PREVOST

**WARRANTY
BULLETIN**

Wb99-18

DATE: SEPTEMBER 1999	SECTION: 06 - Electrical
EXPIRATION: September 2000	
SUBJECT: PROTECTION OF THE RELAYS LOCATED IN THE FRONT SERVICE COMPARTMENT

Figure 2: Front service compartment. (1) Screws to remove.

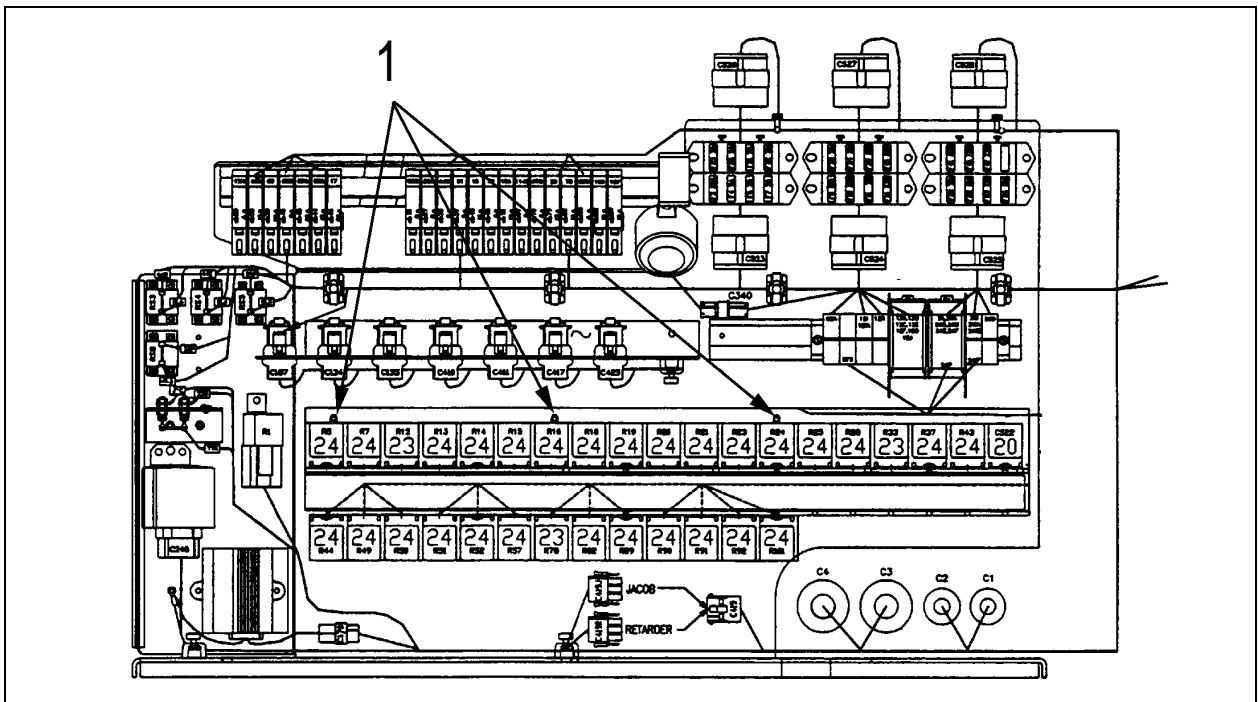
1. Open the front service compartment (figure 1).
2. Remove the relay support fixing screws (figure 2, item 1).
3. Install #286228 protector (figure 3) above the relays at the location shown on figure 2, item 1. Use #500641 screws and #500438 washers.
